Fremont K-8 School

CITY OF LAS VEGAS		DATE:
INTER-OFFICE MEMORANDUM		September 18, 2019
TO: Land Development Services Department of Building & Safety		FROM: Albert Sung, P.E. Flood Control Project Engineer Department of Public Works
SUBJECT:	COPIES TO:	
Drainage Study for:	Lochsa Engineering	
Fremont K-8 School - Update	Clark County School District	
Cross Streets:	SWQ of Maryland Pkwy. & St. Louis Avenue	Bart Anderson, P.E., DevCo
File Number:	F:\Depot\DSMemos\DS5124C.doc	
Parcel Number:	162-03-801-005	
Zoning Action:	SDR-76201 & VAR-76200	
FEMA Flood Zone	YES	NO X
Proposed Storm Drain	YES	NO X

3rd Submittal: Update to raise the finished floor elevations of buildings by about 1'

Subject: Fremont Middle School – DS-05124
Lochsa Engineering Project No. 181203

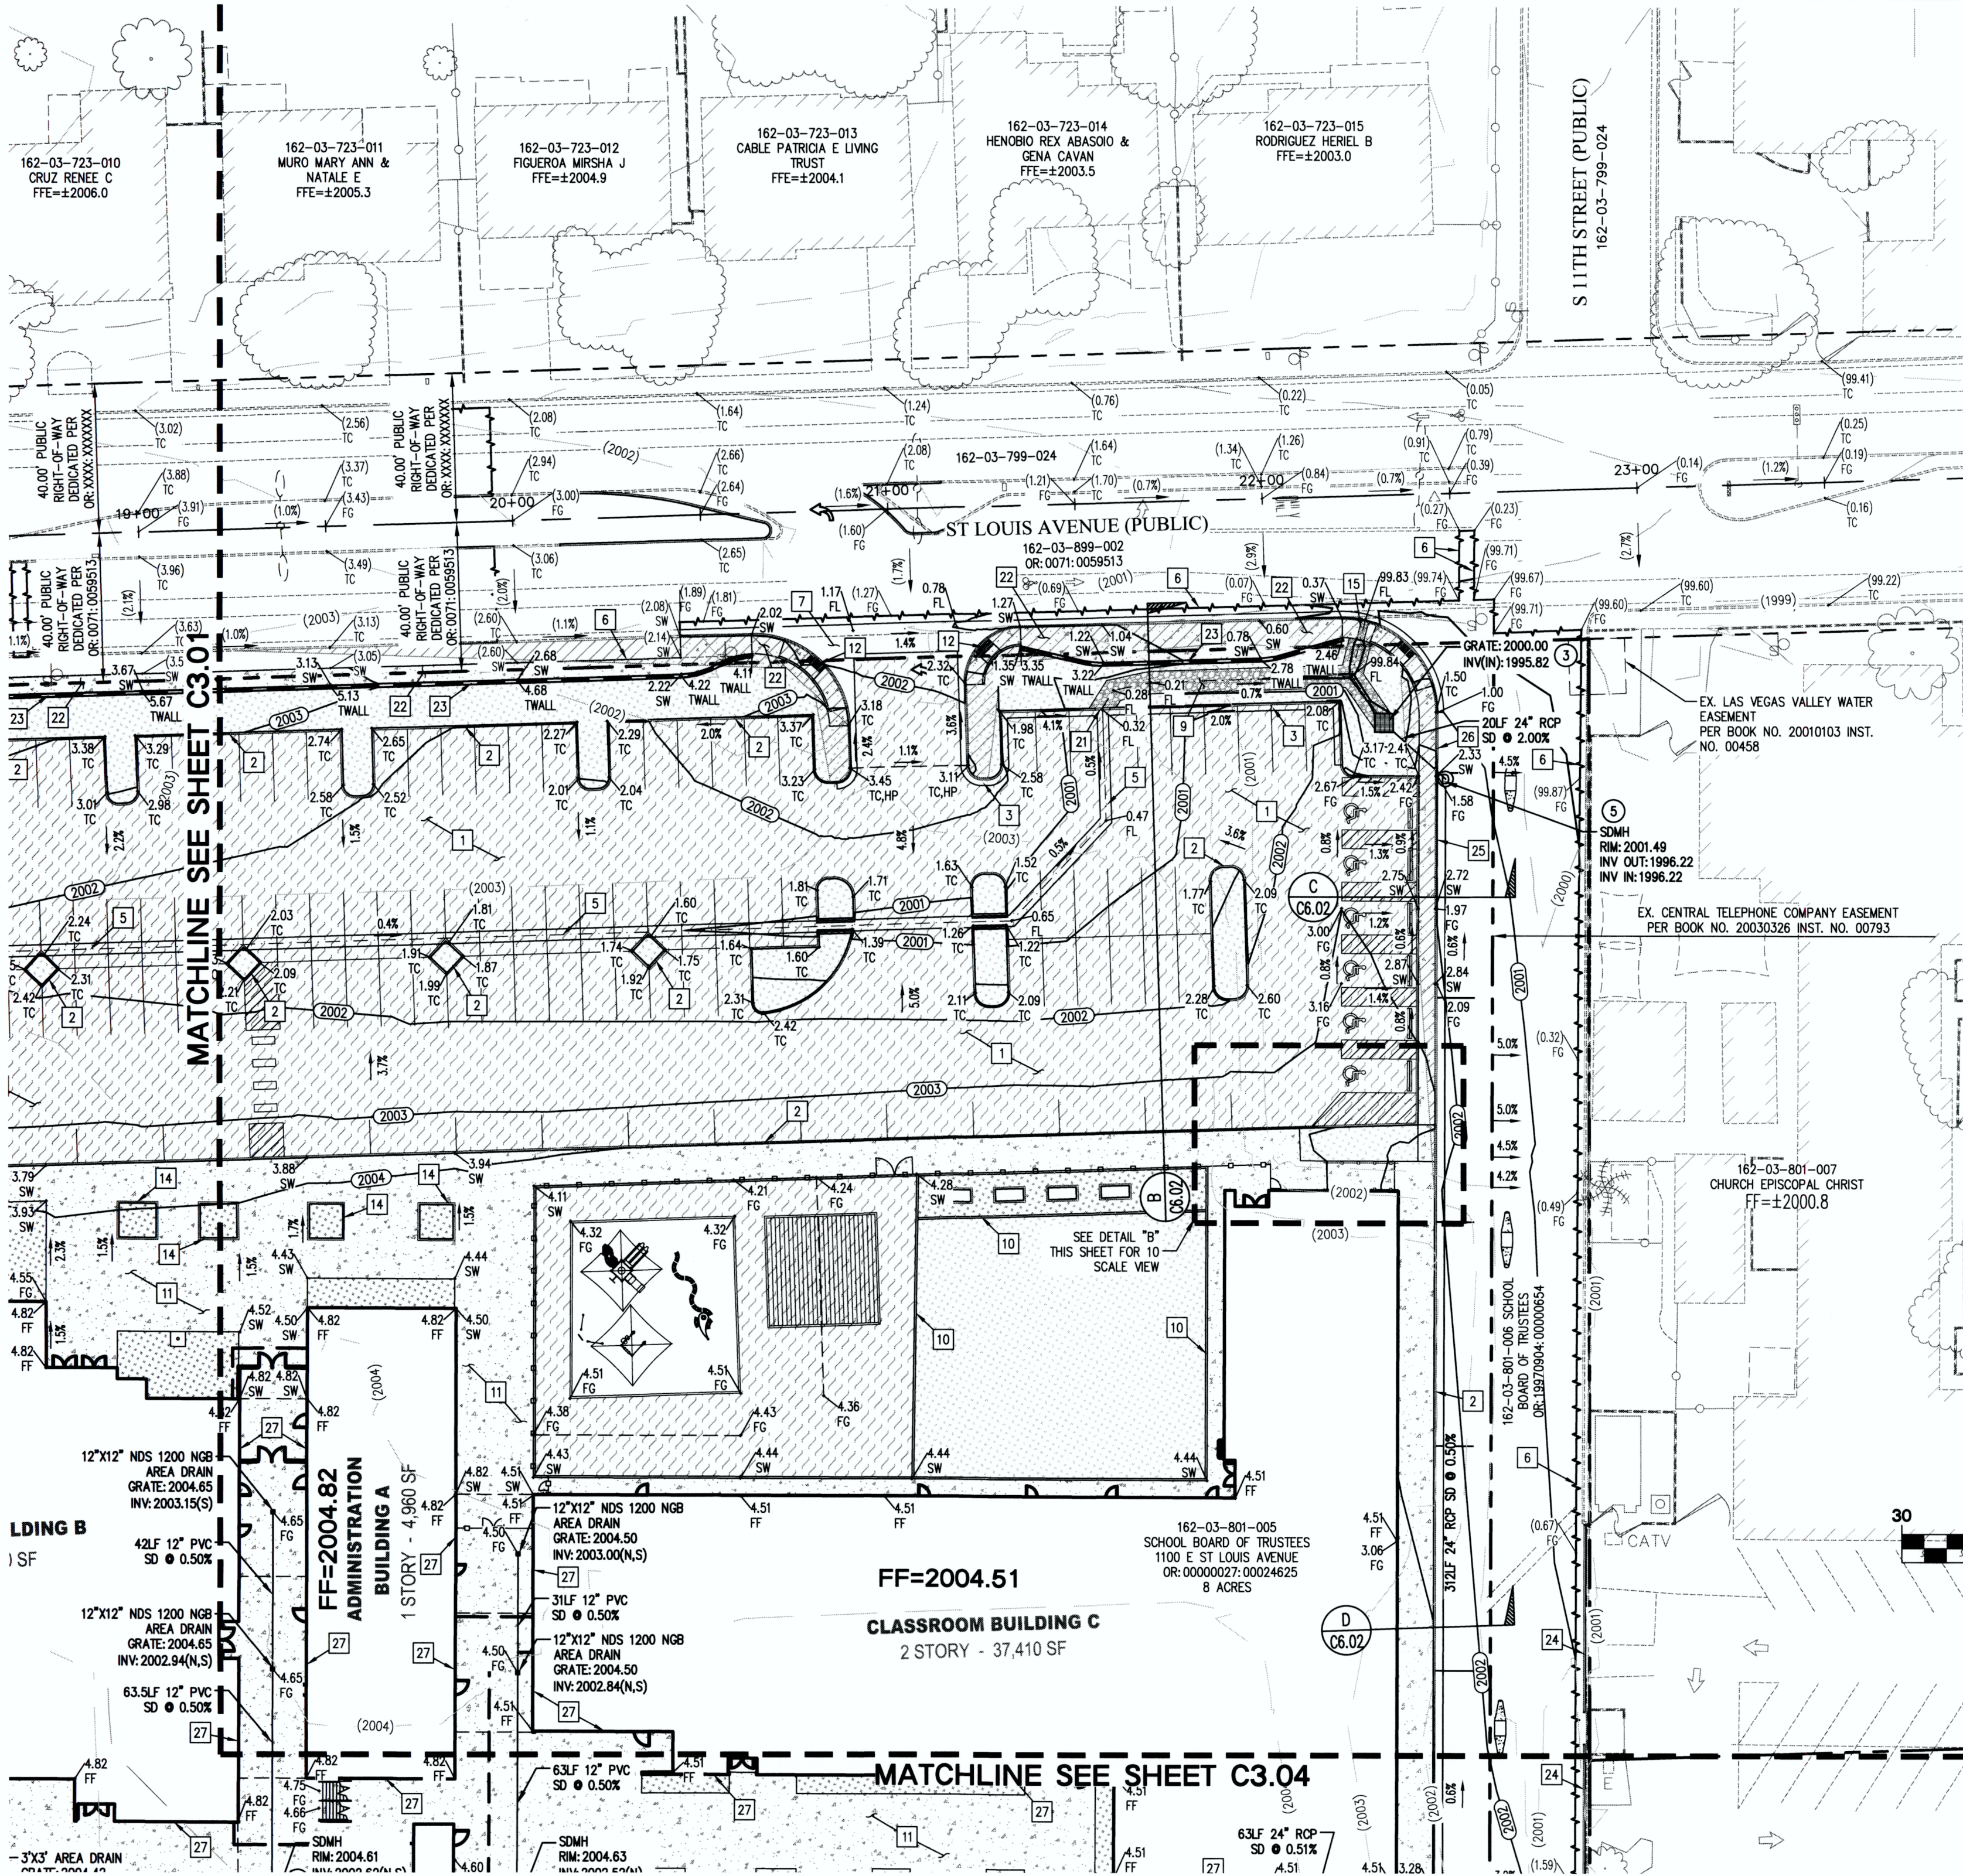
1. Provide a note on the grading plan: *All Onsite Storm Drain Systems and the associated facilities are Privately Owned and to be Privately Maintained by the School.*
2. Add a note in all pertinent sheets for the construction of all storm drain drop inlets per a newly adopted USDCCA Drawing No. 421 (*Stormwater Quality Management Stamp and Sign Detail*).

5. ALL ON-SITE STORM DRAIN SYSTEMS AND THE ASSOCIATED FACILITIES ARE PRIVATELY OWNED AND TO BE PRIVATELY MAINTAINED BY THE SCHOOL.
6. ADD 2000' TO ALL GRADE TAGS.

SHEET NO: DR2

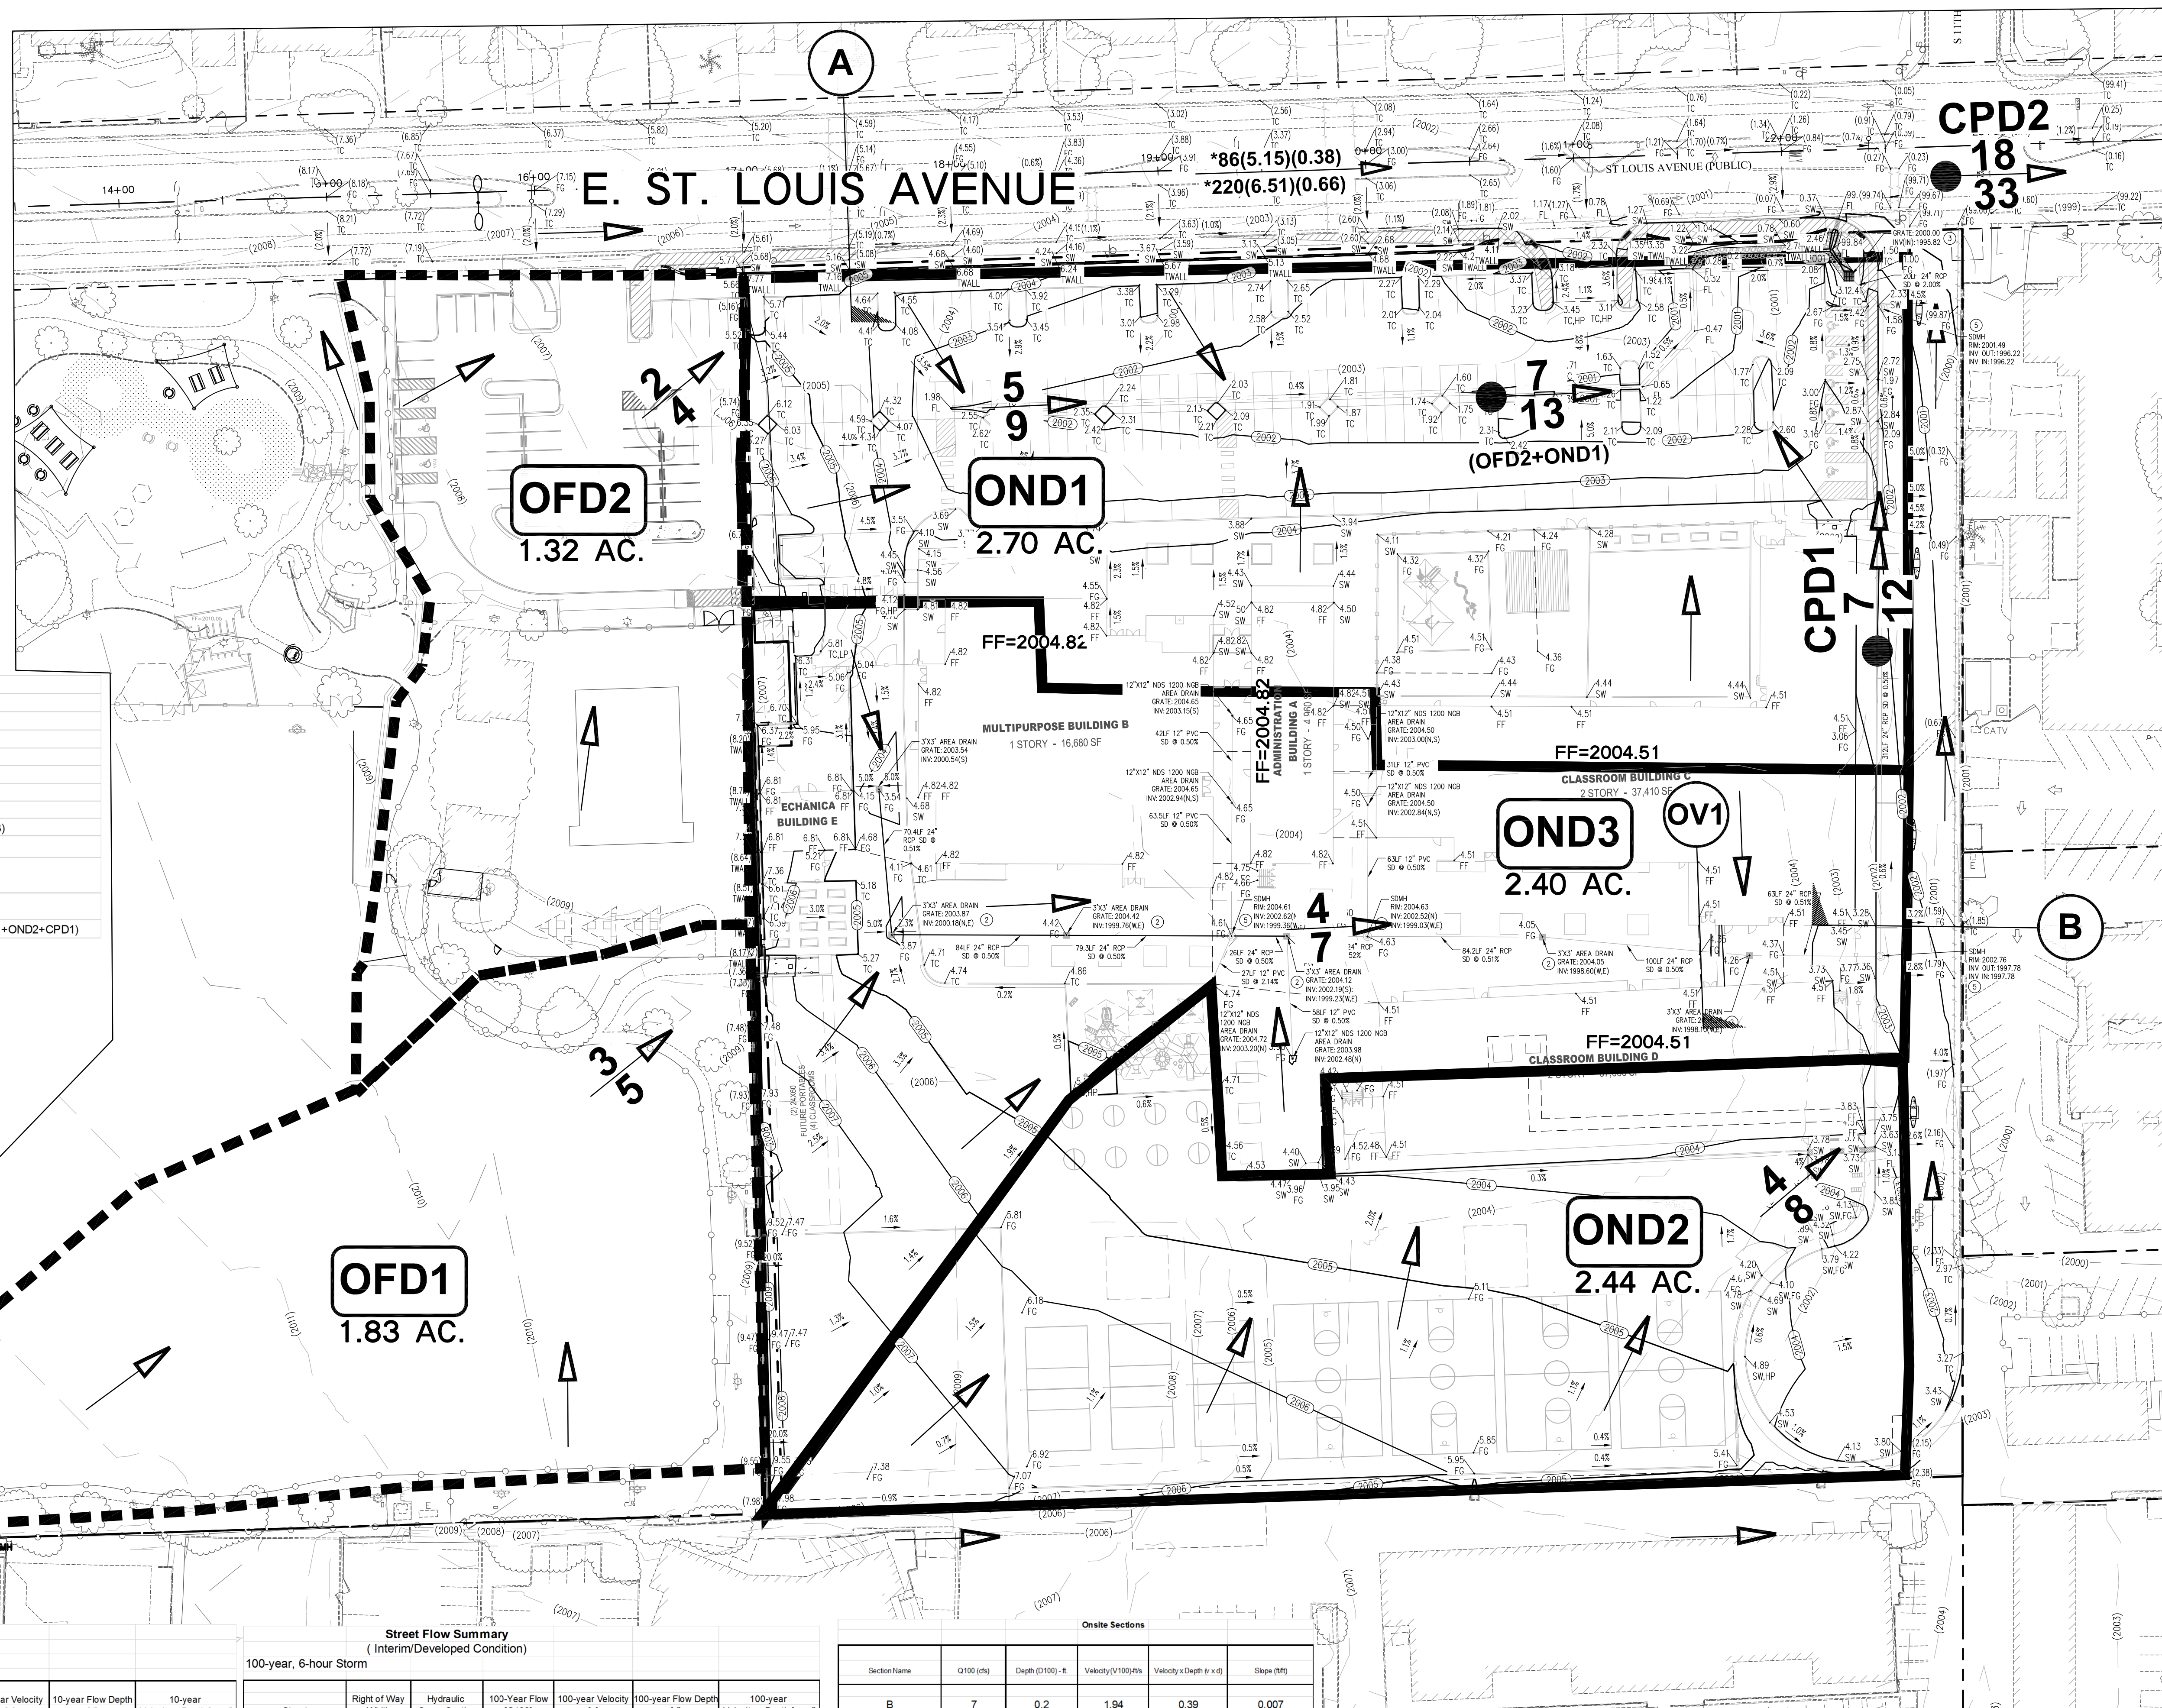
Please refer to the revised grading and Figure DR2, for the new raised finished floor (FF) elevations for the proposed buildings A, (2004.82-ft), B (2004.82-ft), C (2004.51-ft) and D (2004.51-ft). However, the proposed FF does not satisfy the requirement of being double the 100-year flow depth (0.66ft) above E. St. Louis Avenue flow line. However, the proposed FF elevation for the building is set more than 6-inches above the adjacent flow line highpoint elevation and it is protected by the proposed landscaping berm along northern boundary of the subject site that runs along E. St. Louis Avenue.
